Revised Receive State Diagram

Figure 24-11a

IEEE 802.3az Task Force
Chicago, Sep 2009

Figure 24-11a—Receive state diagram, part a

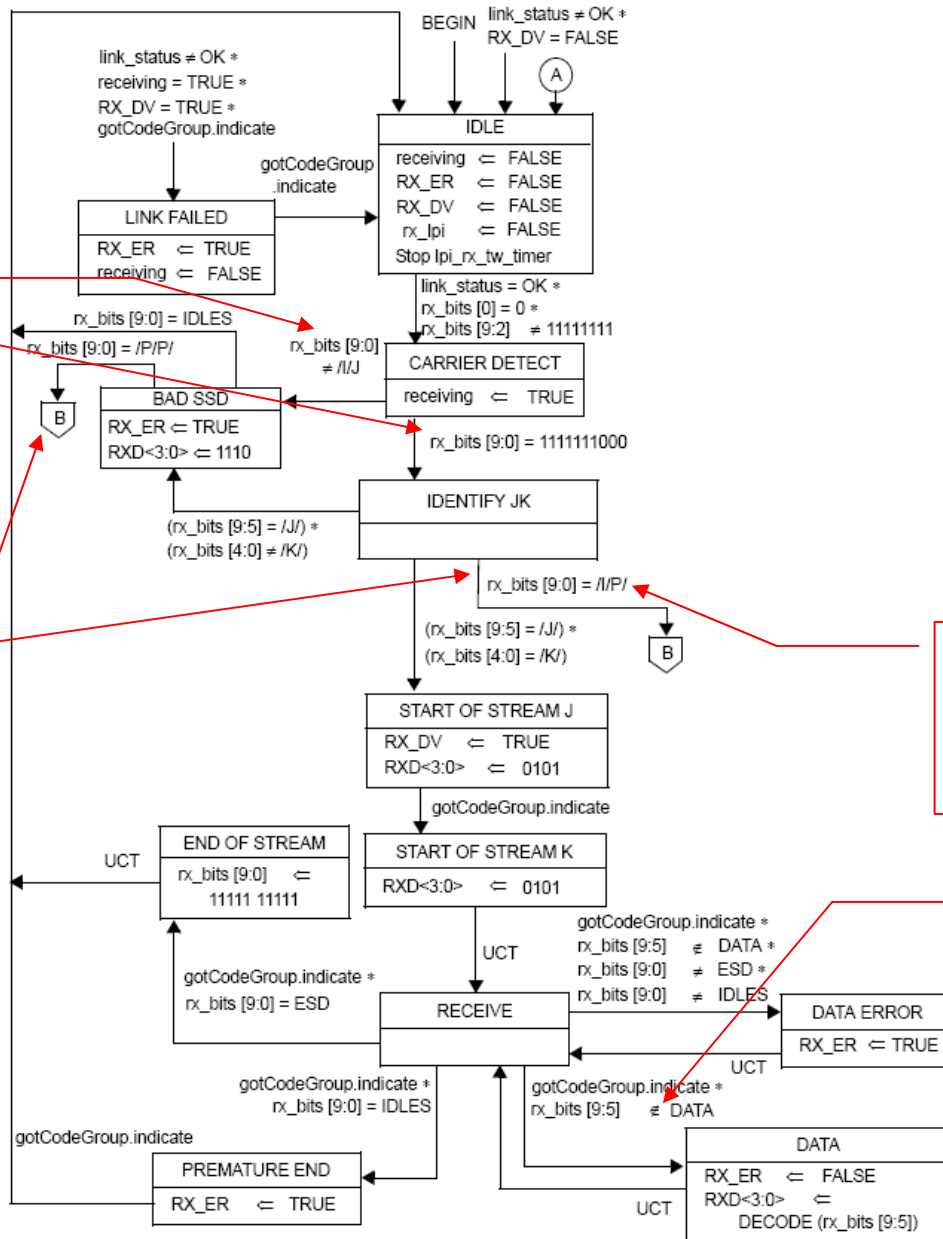
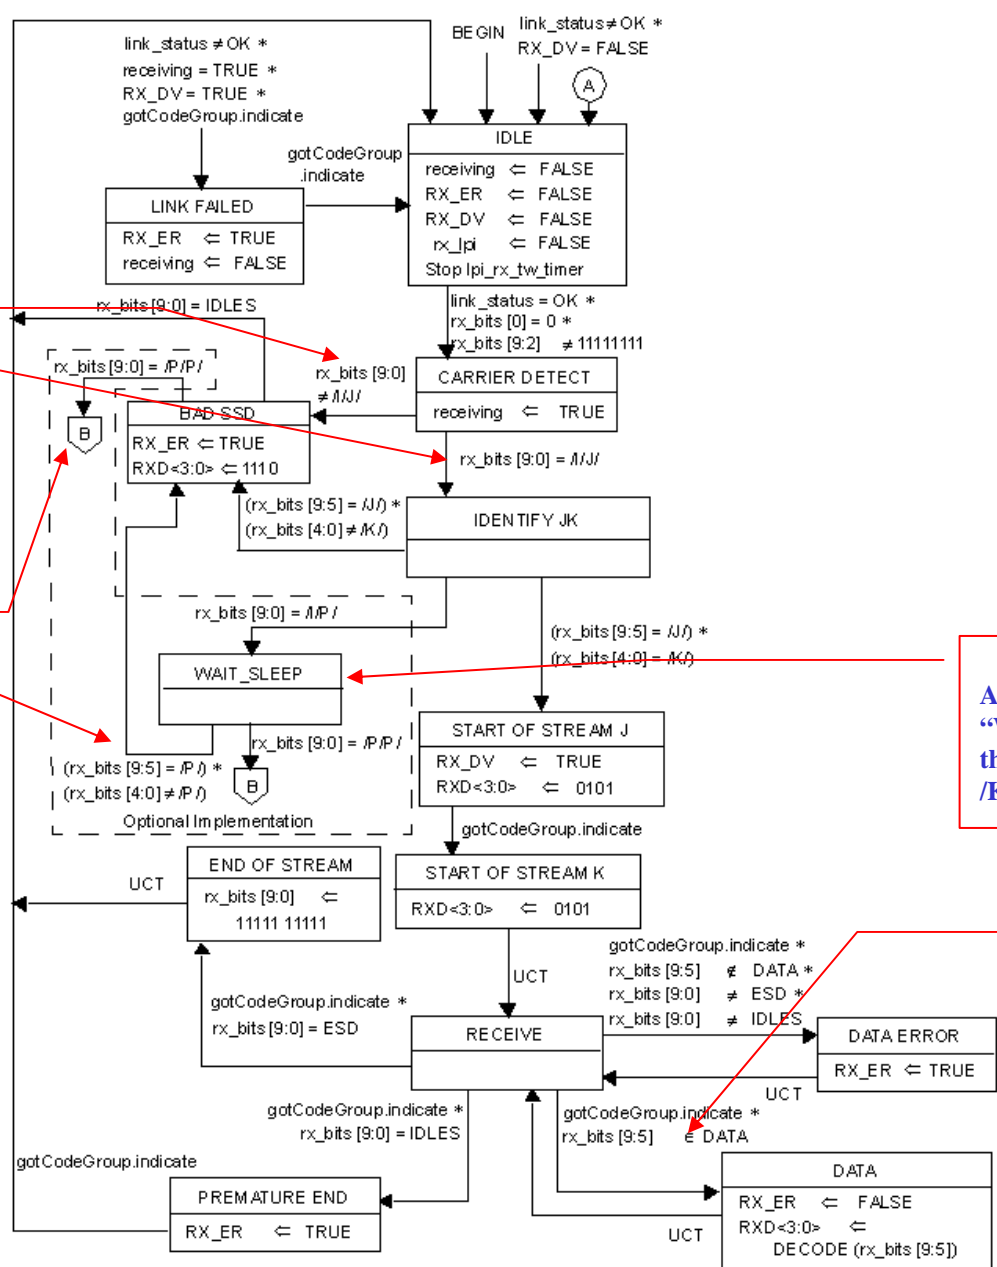
Comment #149
Transition condition is inconsistent

Comment #147
Legacy PHY will not take these optional EEE branches

Comment #151
A single bit error in a /K/ in the SSD /J/K/ can synthesize the sequence `rx_bits[9:0] = /I/P/`

Comment #148
A typo. "not belongs to" should be changed to "belongs to"

Comment #149
Change bit patterns back to symbols

Comment #147
Enclose the optional EEE branches with dashed box and put a note

Comment #151
Add a new state
“WAIT_SLEEP to filter out the single bit error of symbol /K/

Comment #148
Change “not belongs to” to “belongs to”

- ❑ Introduce a new state WAIT_SLEEP between IDENTIFY JK and branch point “B” which goes to START RX_SLEEP
 - The receiver moves to WAIT_SLEEP from the state IDENTIFY JK when a bit pattern 1111100000 is received.
 - It then moves to START RX_SLEEP when receiving two consecutive SLEEP symbols, /P/P/.
 - Any symbol received other than /P/ following a /P/ symbol will lead to the state of BAD SSD
- ❑ Rewrite the transition condition between CARRIER DETECT and IDENTIFY JK
 - Change "rx_bits[9:0] {equal to} 1111111000" back to "rx_bits[9:0] {equal to} /I/J/”
- ❑ Enclose all branches and states which are only needed for EEE with dashed box and put a note saying Mandatory to LPI mode
- ❑ Correct the typo in the branch condition between RECEIVE and DATA
 - Change “rx_bits[9:5] {not belongs to} DATA” to "rx_bits[9:5] {belongs to} DATA”
